**Sandyford Business District
Cycle Infrastructure Review**

**Enforcement and
Maintenance Issues**

P18-055-DG-005

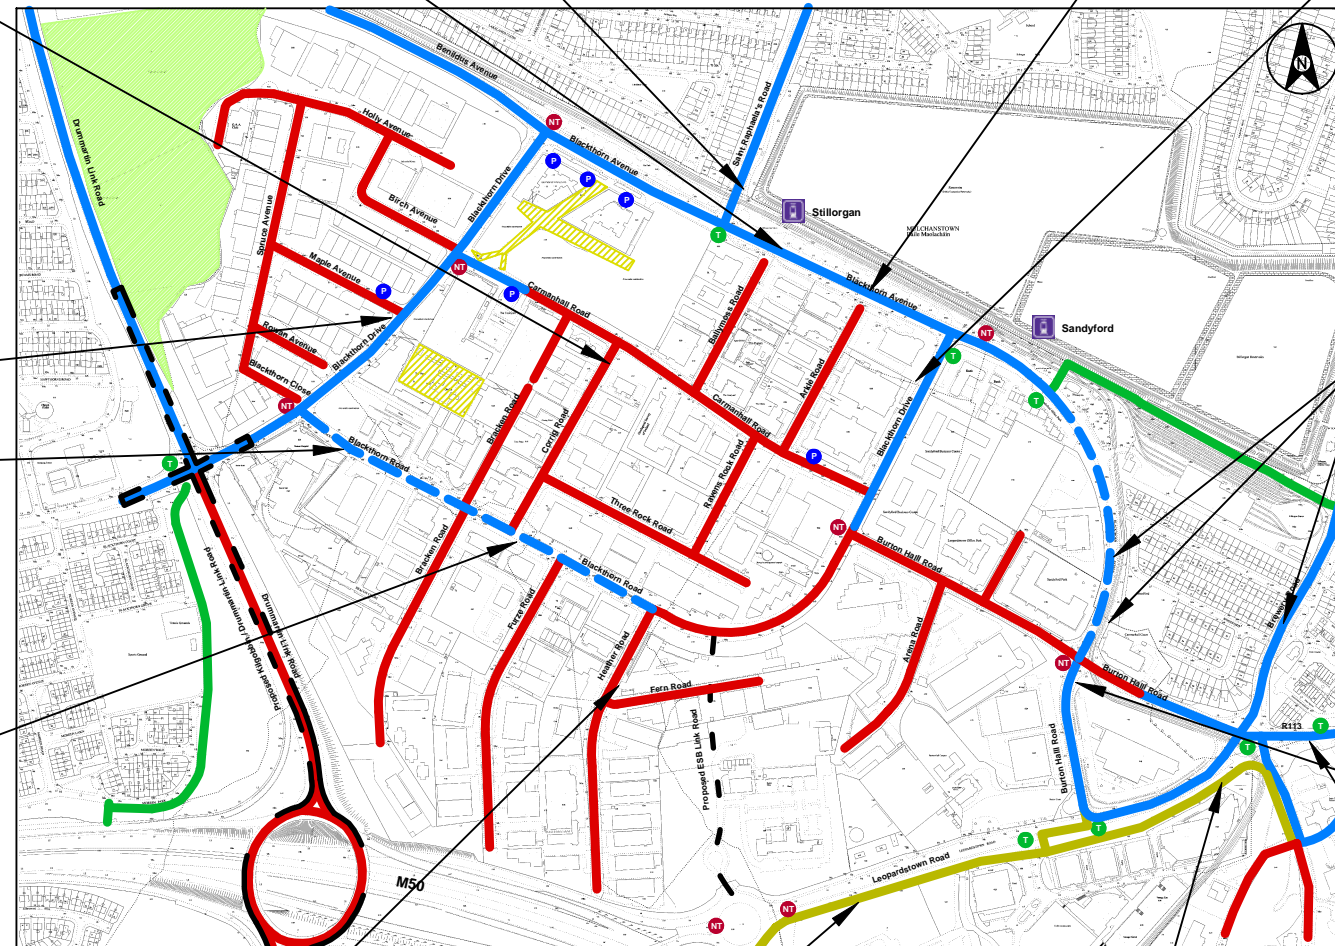
Gullies not flush with the pavement

Manholes in cycle lane

Grass encroaching cycle facilities

Poor pavement condition

Manholes in cycle lane/track

Traffic blocking cycle lane

Shrub is encroaching on footpath resulting in pedestrians walking into cycle lane which may result in a cyclists/pedestrian collision. Cut back vegetation.
